# ADDENDUM NO. 05 – PORTAGE PUBLIC SCHOOLS – CENTRAL ELEMENTARY SCHOOL BP 4: CONSTRUCTION

# ADDENDUM NO. 5 (BP4)

PROJECT: Central Elementary School Bid Package 4: Construction

ARCHITECT'S PROJECT NO.: 21-237.10

DATE

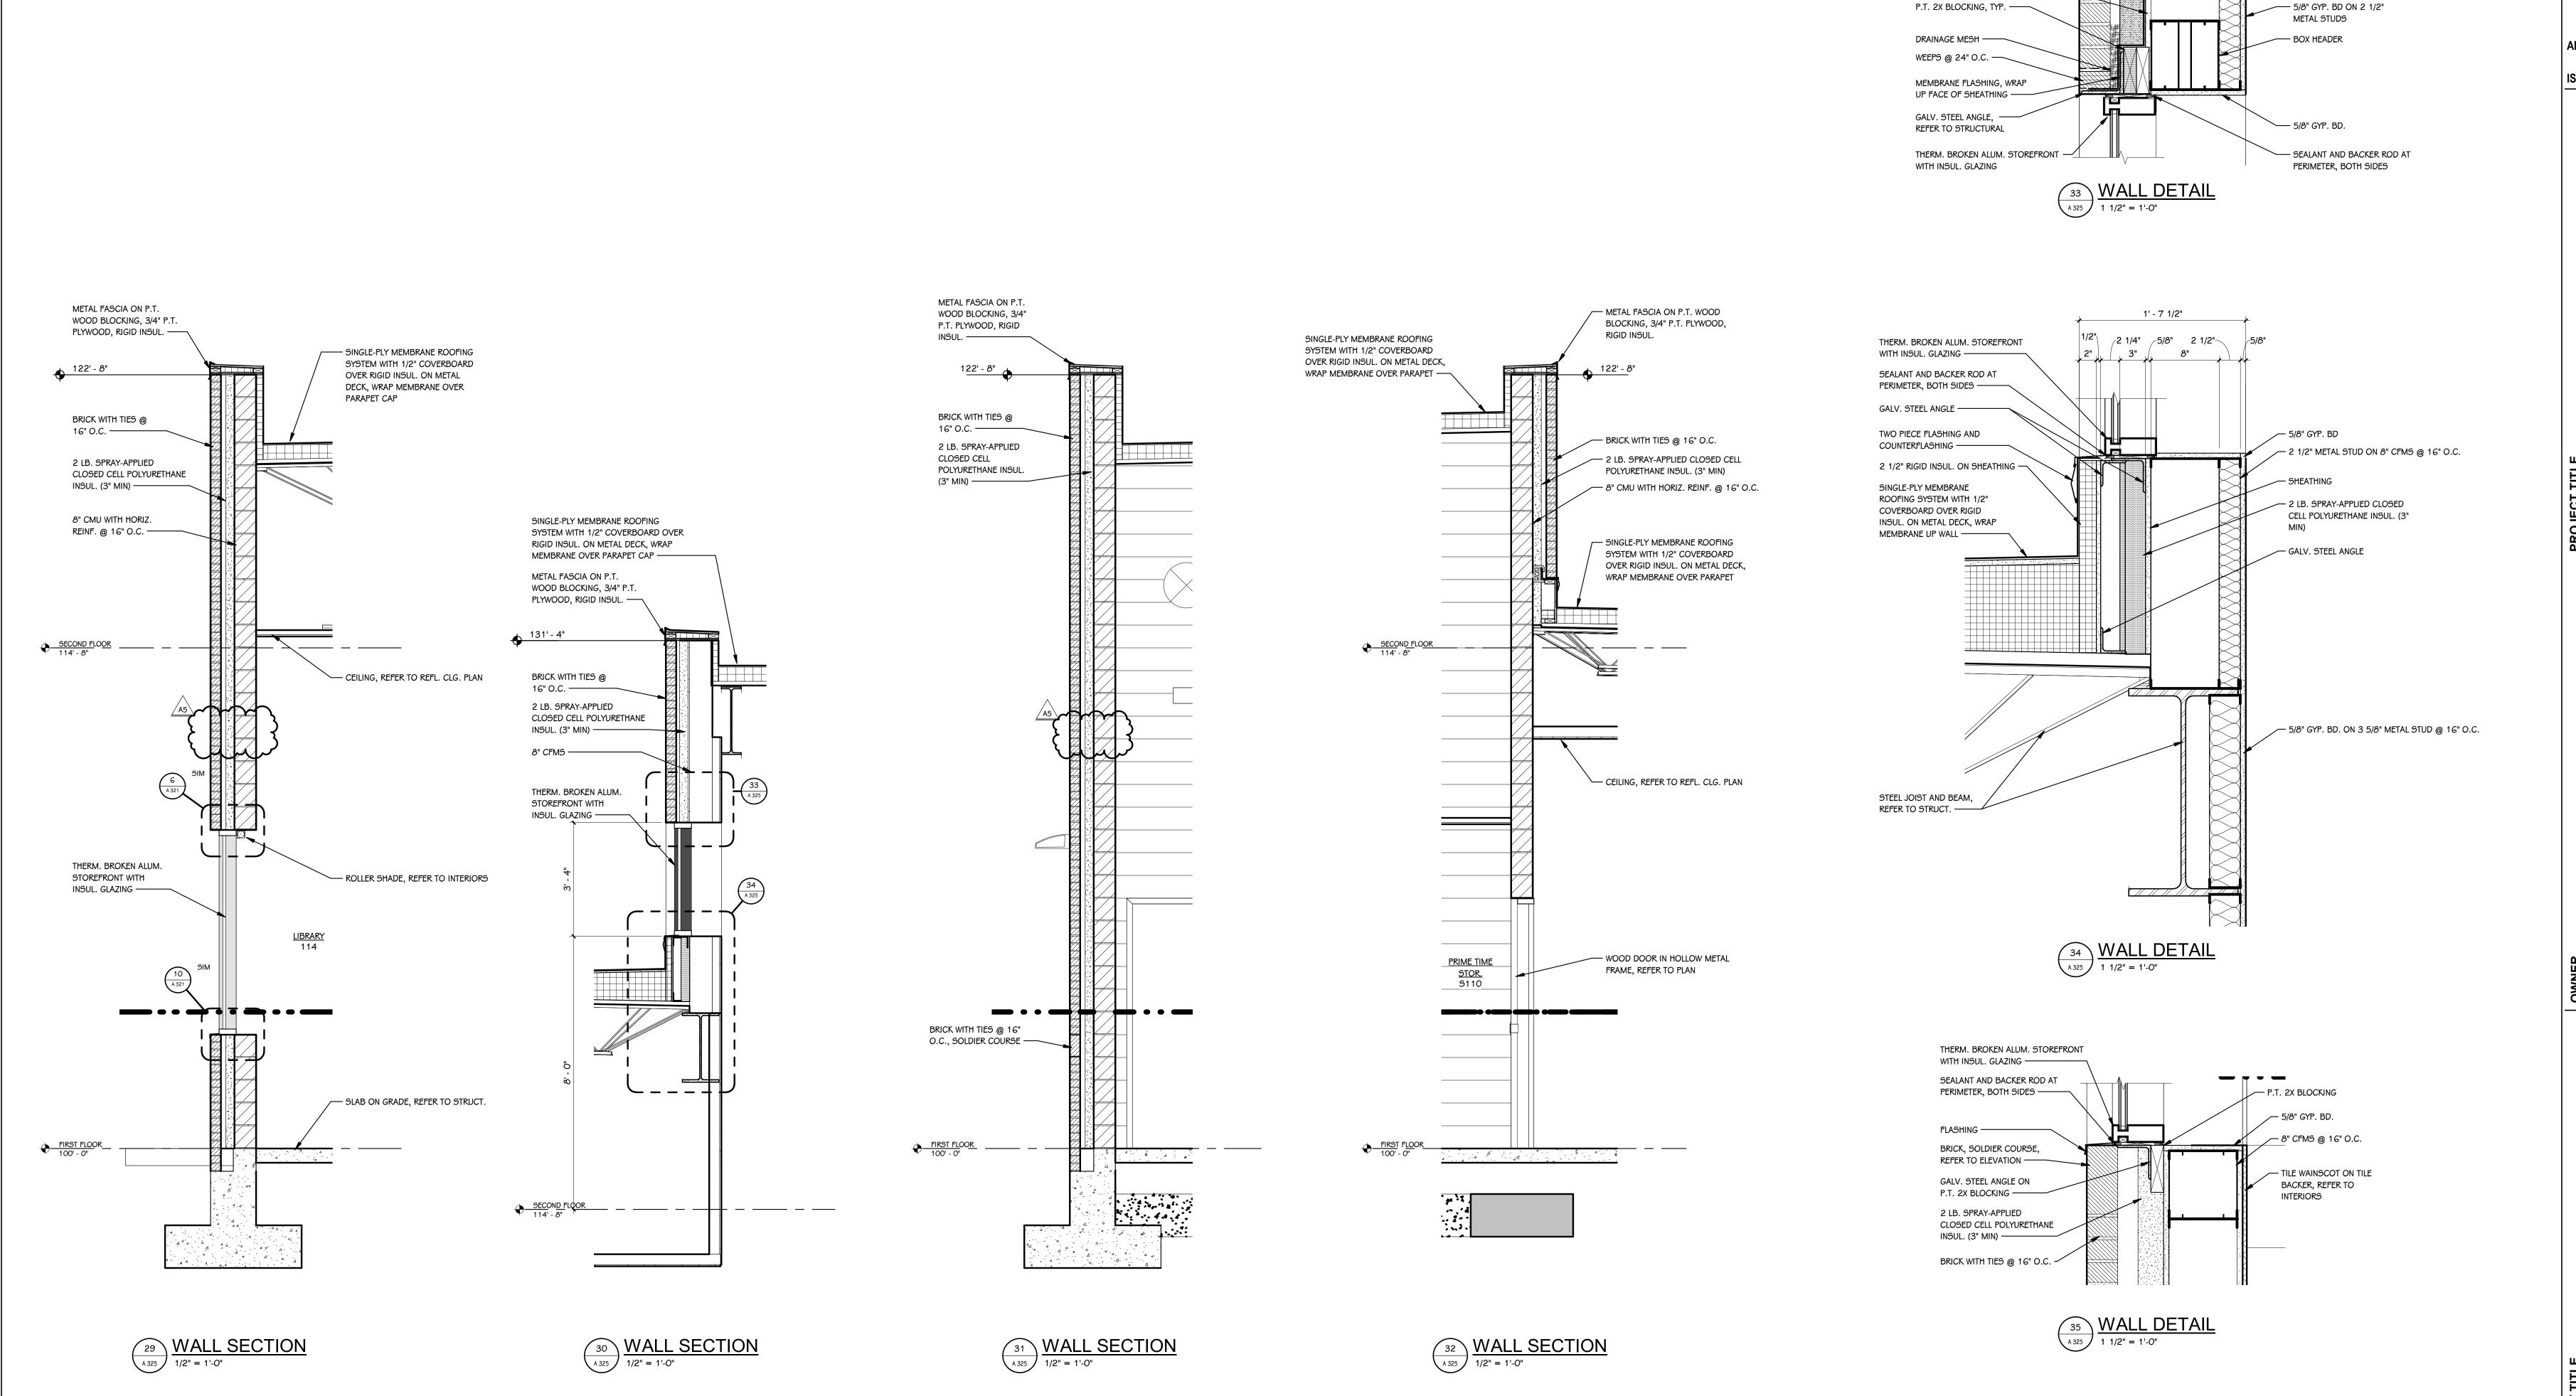
#### ADD-5 Item No. D-7 - Thermal Brackets at Veneer Bearing

Fero Fast thermal bracket detail updated. Thickness of continuous shelf angle is revised.

Revised wall sections to remove shelf angle and bracket in alignment with 2<sup>nd</sup> floor openings. Revised shelf angle and bracket note, added typical note to 1/A321, provide membrane flashing, cavity drainage mesh, weeps and vents at shelf angle [12'-0"h locations].
